**Town of Kittery  
Planning Board Meeting  
August 8, 2019**

**ITEM 1 – 76 Dennett Road – Site Preliminary Plan Review**

**Re: Response to Review Comments**  
Proposed Mixed-Use Residential  
Development Project  
76 Dennett Road, Kittery, ME 03904

**RE: Town of Kittery, Planning Board Services  
Mixed-Use Development Proposal – 76 Dennett Road Lots 6-15B, 6-16A, 13-4  
Preliminary Plan Approval Application  
Review of HTA Responses dated July 25, 2019; and  
MDOT Traffic Movement Permit Application dated July 1, 2019  
CMA #591.125**

REAR UTILITY PLAN  
**C14**  
 PROJECT NO. 569200  
 SHEET 14 OF 25

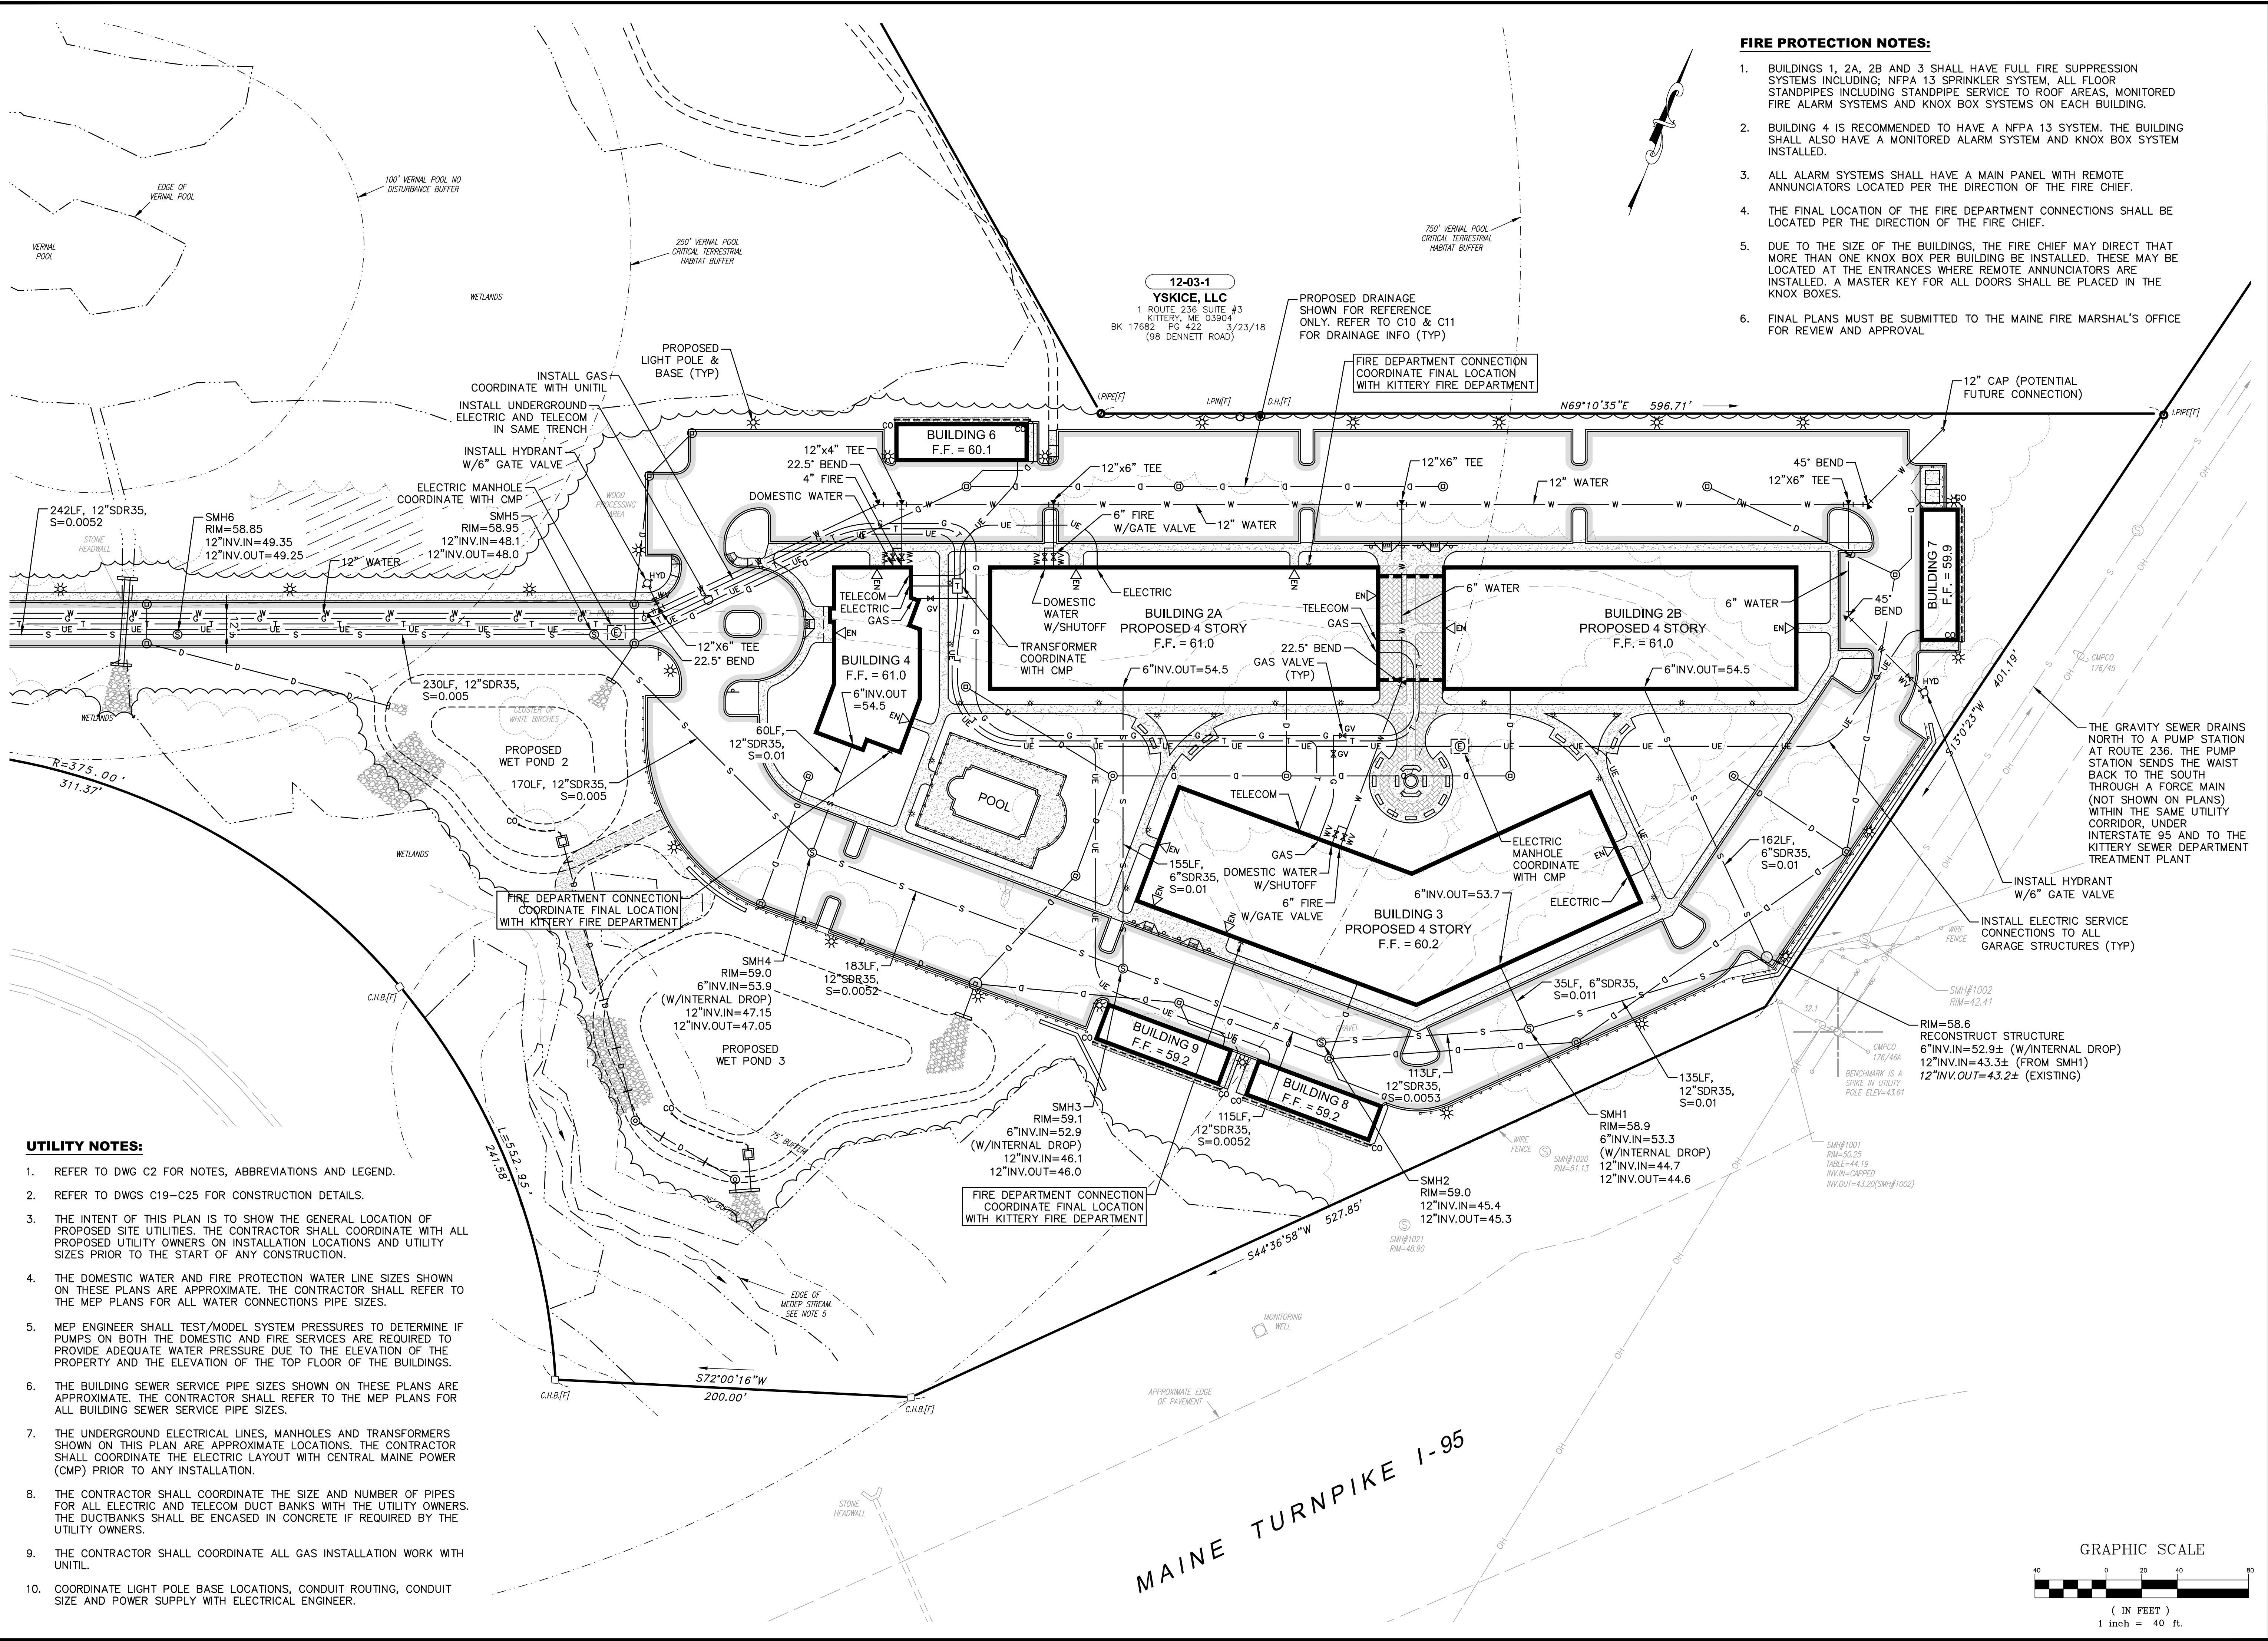
- *The KWD suggests that booster pumping may be required to serve all the locations and elevations. How is that decision going to be made? No provisions are currently made on the site plan for such facilities as needed.*

- *Conventional sewer services and sewerage layouts have been incorporated. The system ties into a sewer manhole on what appears to be a KWD interceptor. For clarity, the applicant should provide additional schematic details indicating how piping goes from that connection to the WWTP.*

- The KWD suggests that booster pumping may be required to serve all the locations and elevations. How is that final decision going to be made? No provisions are currently made on the site plan for such facilities if needed.

*The requirement in the LUDC is that the Water District determine that the supply and pressure are available to serve the development. The pressure issues are important, should be identified at this stage of the project. HTA should be capable of making these preliminary determinations. The facilities that may be necessary for service should be identified and included on the site plan.*

Utility Note #5 was added to the Utility Plans on Sheets C13 & C14 specifying that the MEP engineer is responsible for testing and modelling the water pressure and designing the systems accordingly.

The fire supply line sizes are approximate. Utility Note #4 on Sheets C13 & C14 specifies the final sizes will be based on the MEP design plans. KWD has reviewed the schematic layout and approved the domestic water and fire service configuration.

A note was added to Utility Plan Sheet C14 detailing the connection to the WWTP.

*A note has been added indicating a future MEP engineer will be responsible for testing and modelling the water pressure and designing the systems accordingly.*

FRONT LANDSCAPING PLAN  
**C17**  
 PROJECT NO. 569200  
 SHEET 17 OF 25

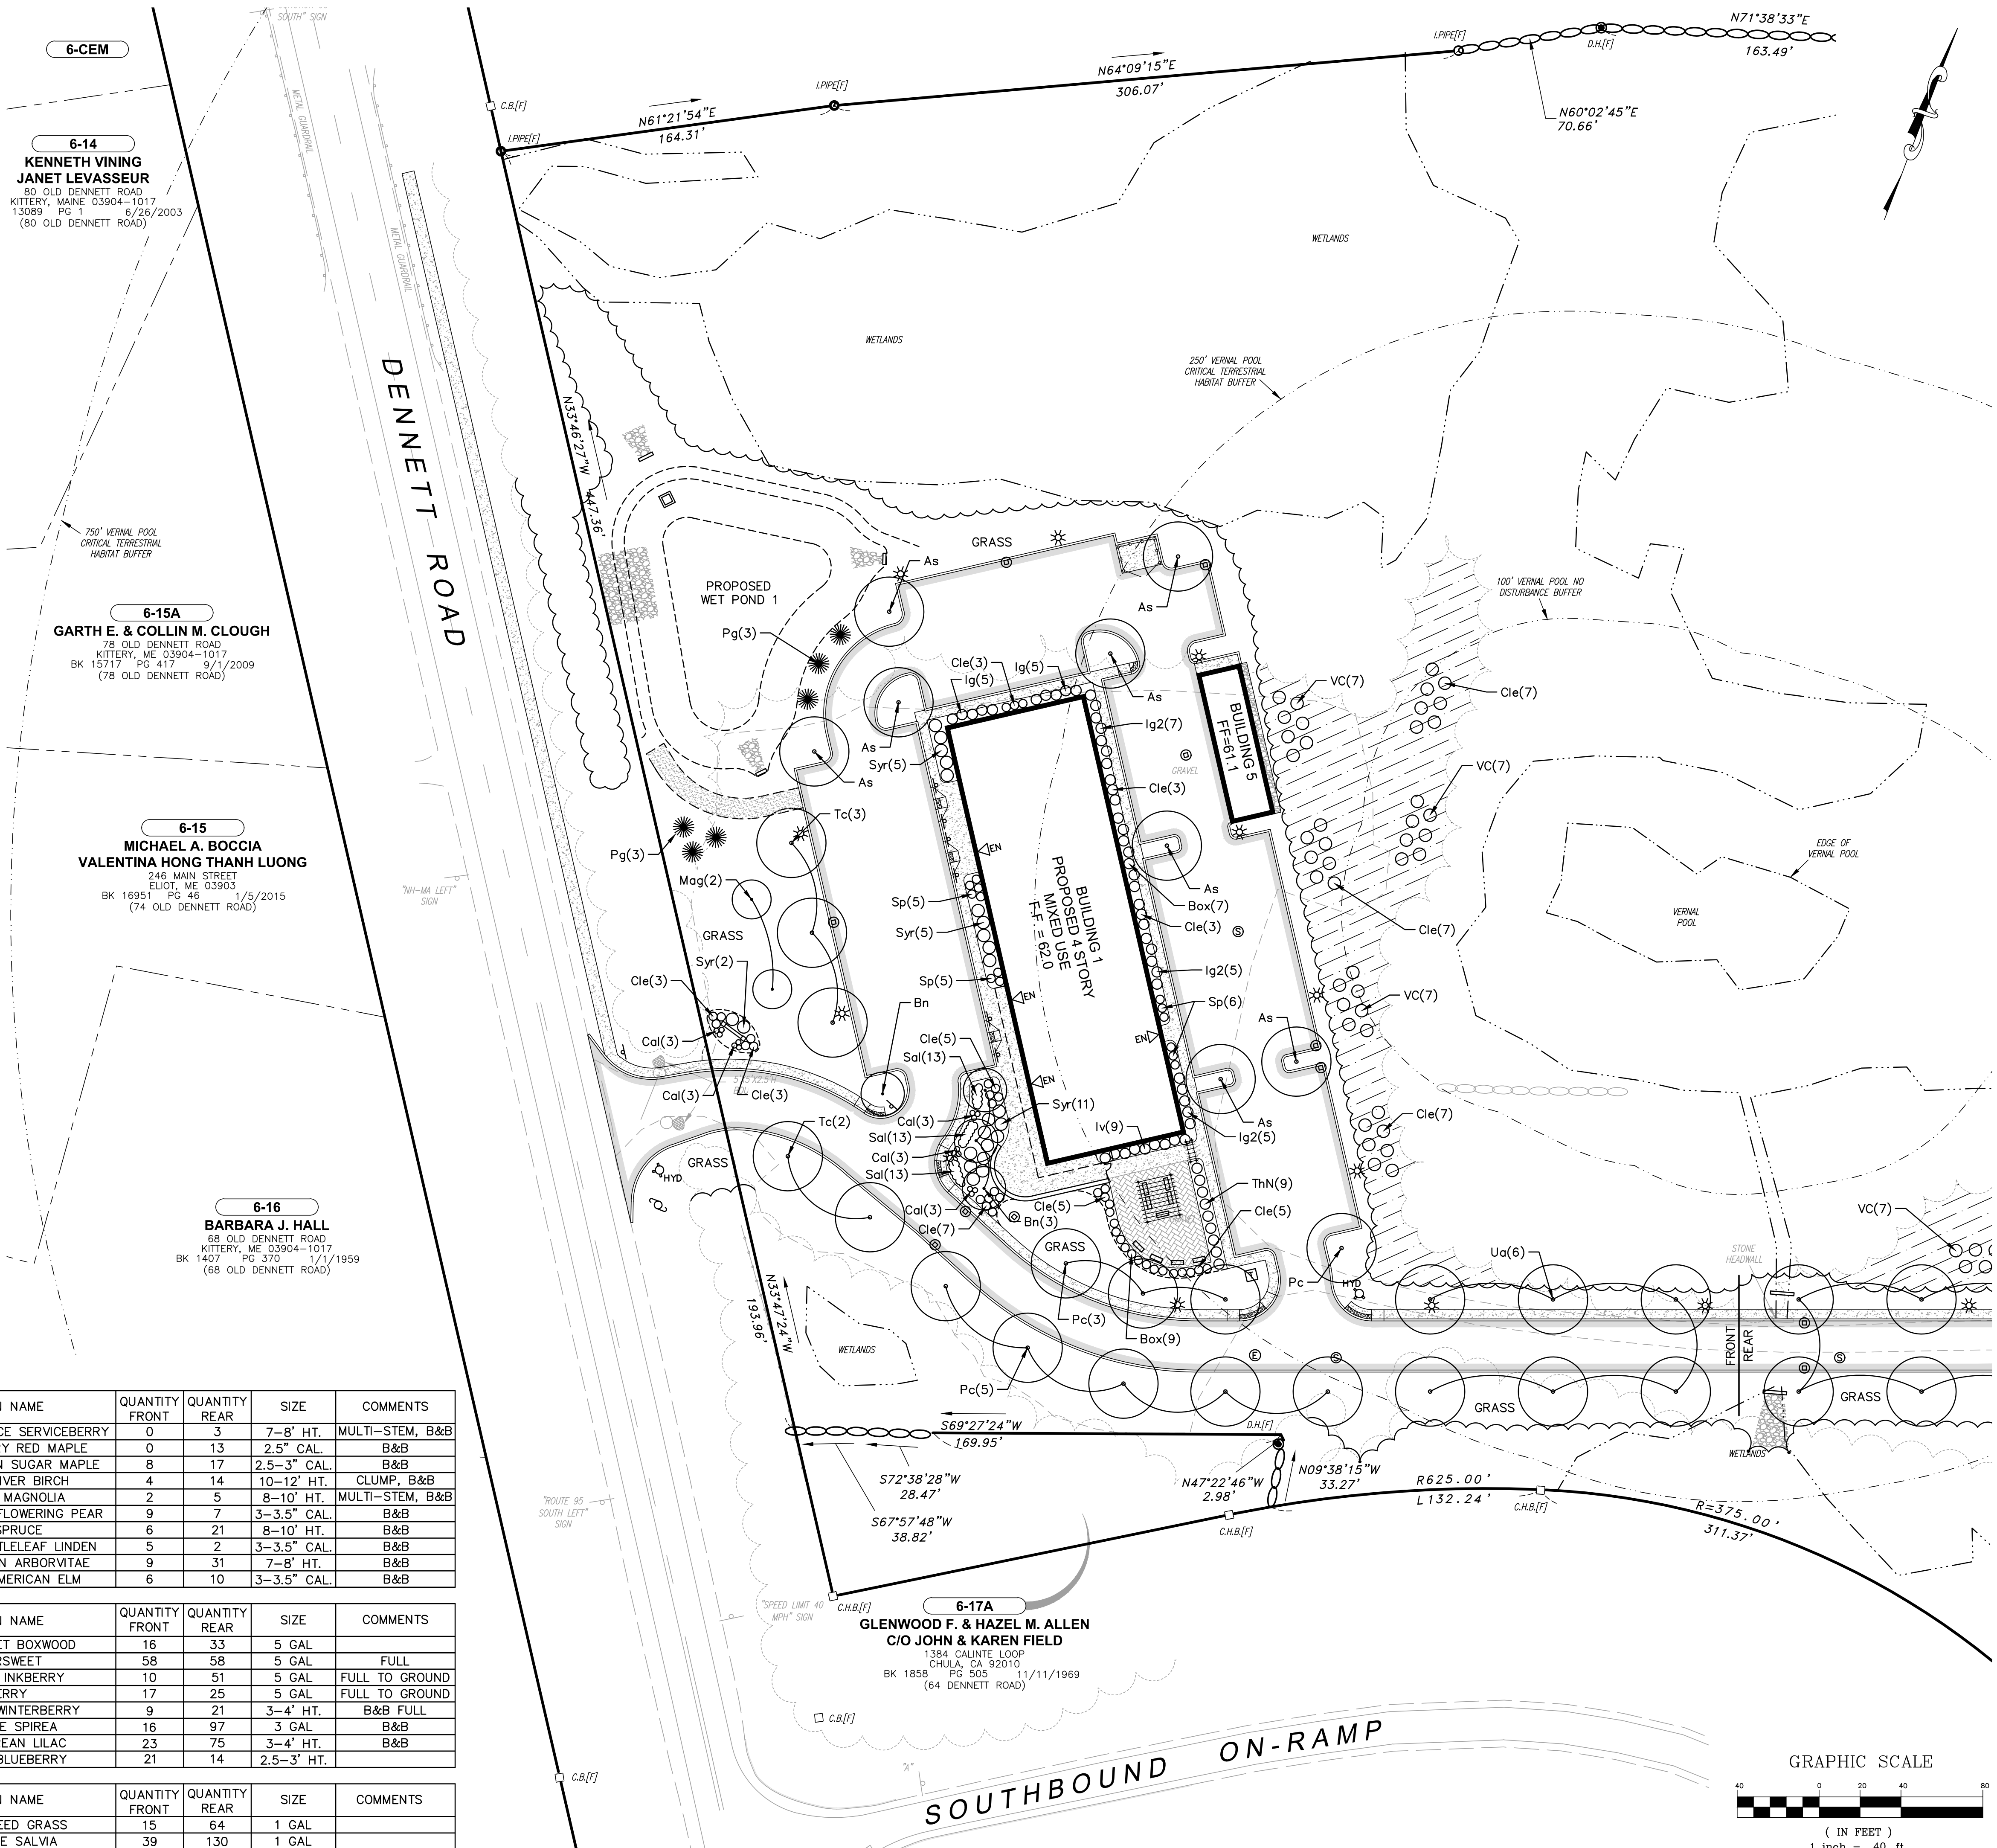
- *The landscaping plan does not appear to have been prepared by a registered landscape architect. It is detailed, with extensive plantings with multiple species. The applicant should describe how the plan was developed and the qualifications of the designer.*

- (a) The landscaping plan appears not to have been prepared by a registered landscape architect. It is detailed, with extensive plantings with multiple species. The applicant should describe how

the plan was developed, and the qualifications of the designer. The Planning Board may desire a landscape architects design input, as provided in this provision of the ordinance.

***Does the Planning Board accept the landscape plan being prepared by HTA, without registered LA professional?***

The Town of Kittery regulations allow for the landscape plan to be prepared by other design professionals at the discretion of the Planning Board. Hoyle, Tanner has provided landscape design on numerous large scale projects in the seacoast area as well as the state of Maine and we feel the prepared landscape plans satisfies the requirements set forth in the Town of Kittery Land Use & Development Code. The planting list, quantity, size and layout are consistent with other developments in close proximity to the project. All species are readily available at local nurseries and are resistant to the harsh New England climate.

Hoyle, Tanner will work with Town Staff to make any necessary changes to the landscaping plans to ensure this standard is met.

*HTA notes that the Kittery LUDC provides that design professionals other than registered landscape architects may be allowed to prepare landscape plans, with at the Planning Board's discretion.*

*"HTA will work with the Town Staff to make any necessary changes to the landscaping plans to ensure this standard is met."*
